Access Compliance Report

Public Rights-of-Way

(Curb Ramps)

Intersection ID: 53284	Main Street: BENFIELD_RD	Cross Street: I-485_RA	Location: W
ADA ID: 269814326DC0	Ramp Type: Perp	Initial Pass/Fail: Fail	Overall Compliance: No
Severity Score: 13.75			
Codes/Mitigation Info/Possible Solution		Field Measurements/Component Compliance

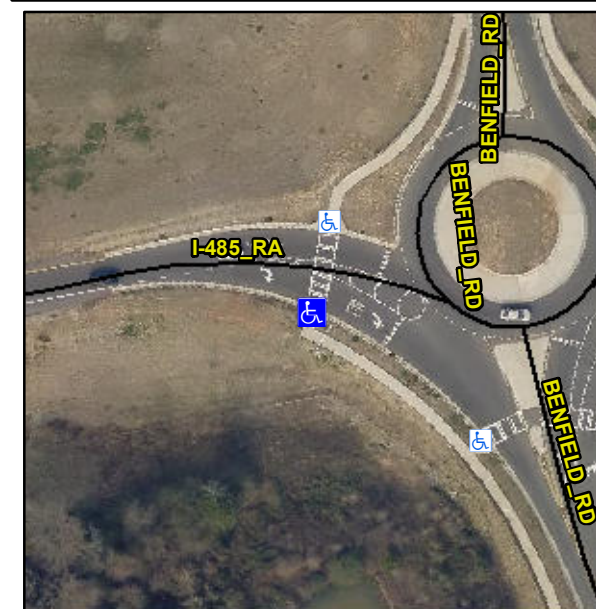
Remove & Replace Entire Ramp.

R304.2.2, R304.5.3
